SUBDIVISION REPORT - CONCEPT/DEVELOPMENT PLAN

▶ **FILE #:** 6-SC-23-C
6-C-23-DP

▶ **SUBDIVISION:** MAYA HILLS
▶ **APPLICANT/DEVELOPER:** URBAN ENGINEERING, INC.
OWNER(S): Hardin Valley Investments, LP

▶ **PROPOSED USE:** Attached residential subdivision

PROFILE-ROAD 'A'
 1"=50' (HORIZONTAL)
 1"=5' (VERTICAL)

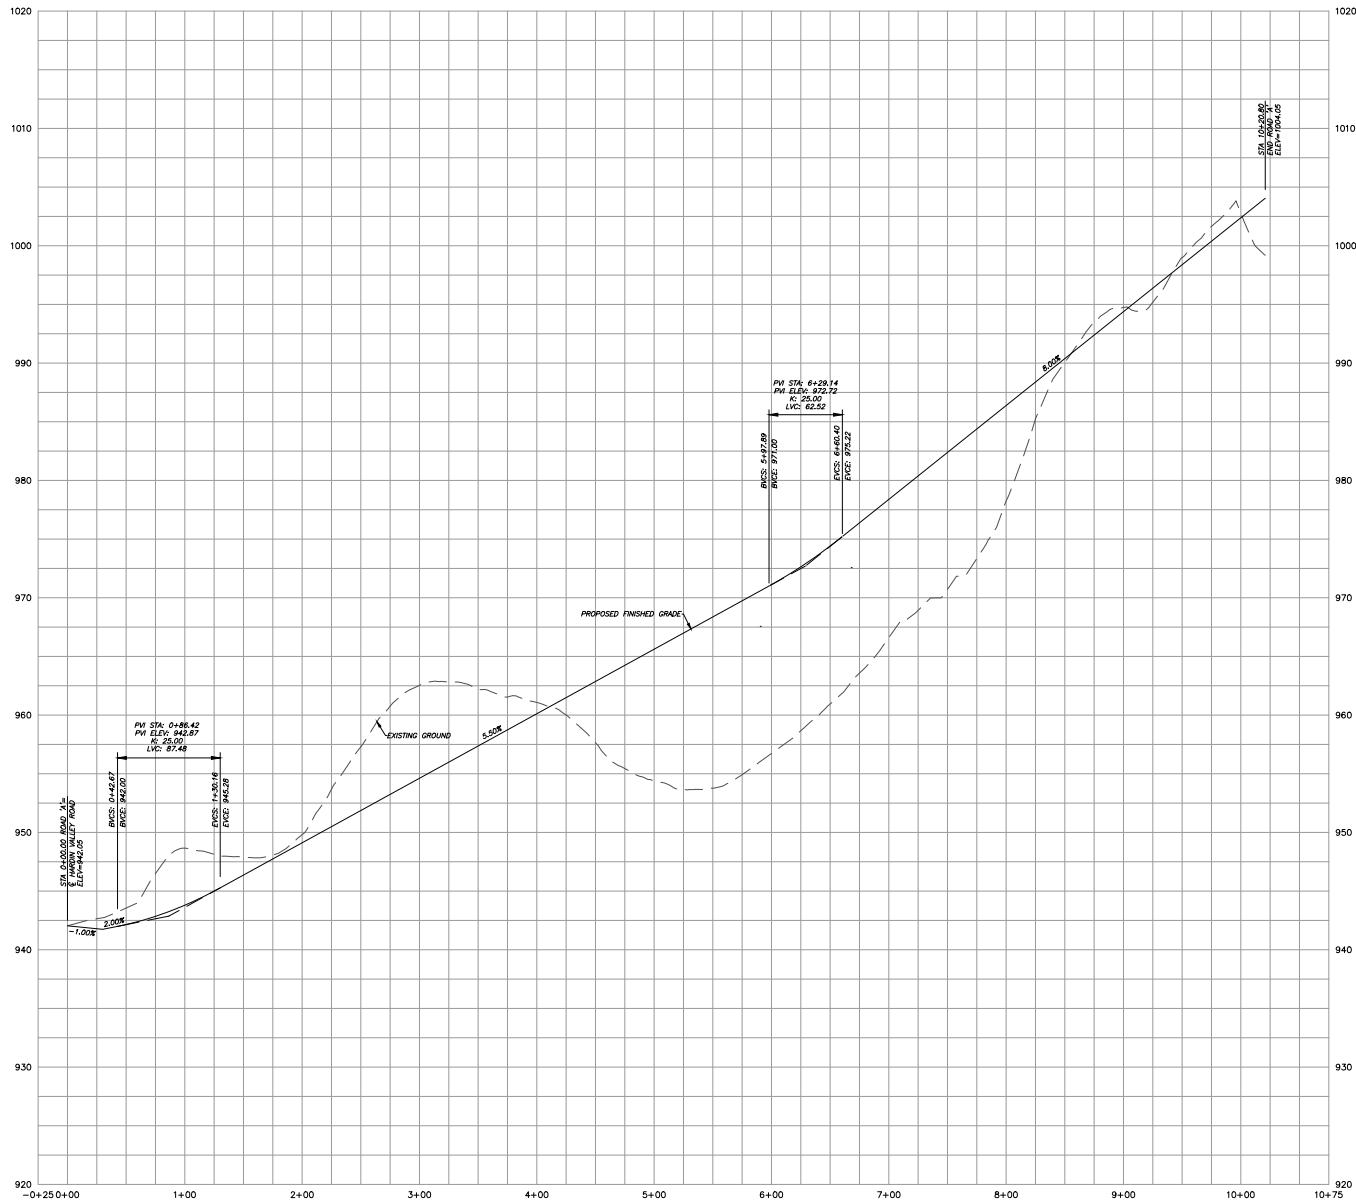
1. Increase the maximum intersection grade from 1 to 2 percent on Road 'A' at the Hardin Valley Road intersection

Approve as requested since no unsafe conditions are created.

SHEET C-5

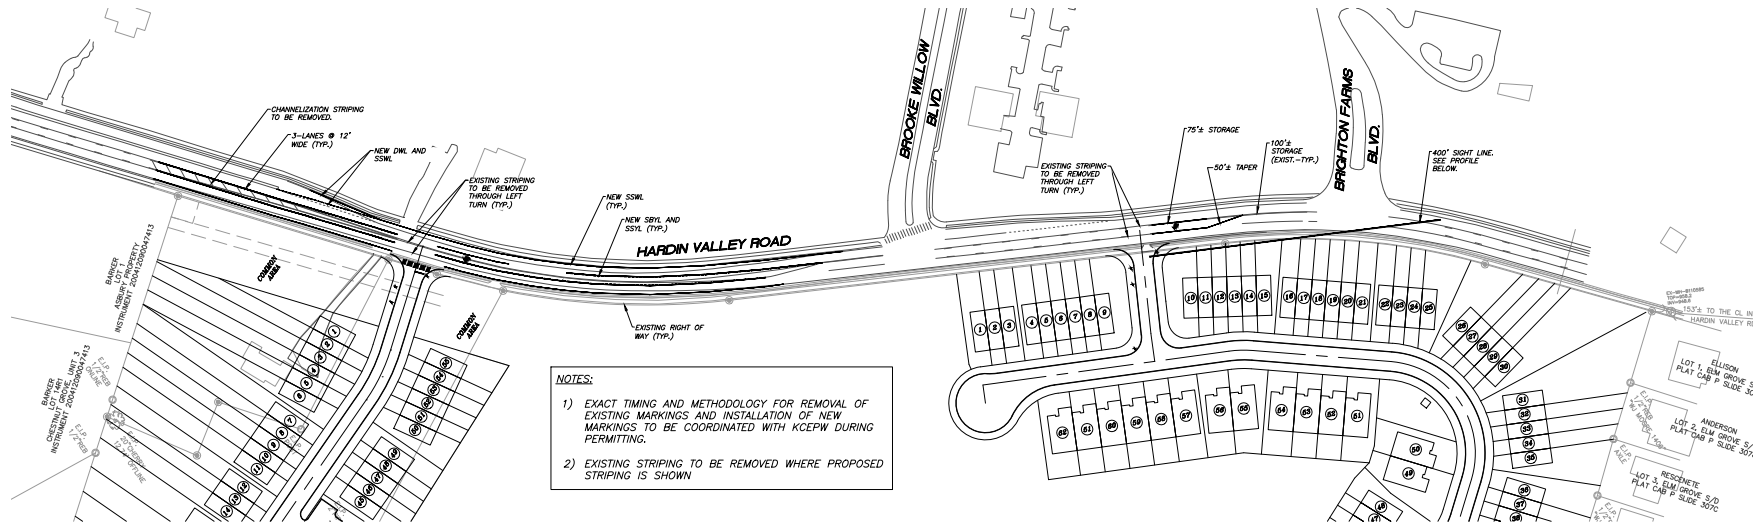
To the west of the proposed Maya Hills Entrance on Hardin Valley Road, the modification of the pavement striping will entail removing the center transverse crosshatching.

- 2c) The double yellow centerline in the center of Hardin Valley Road should be removed in front of the new Maya Hills Subdivision entrance to accommodate this new intersection with the new turning movements.
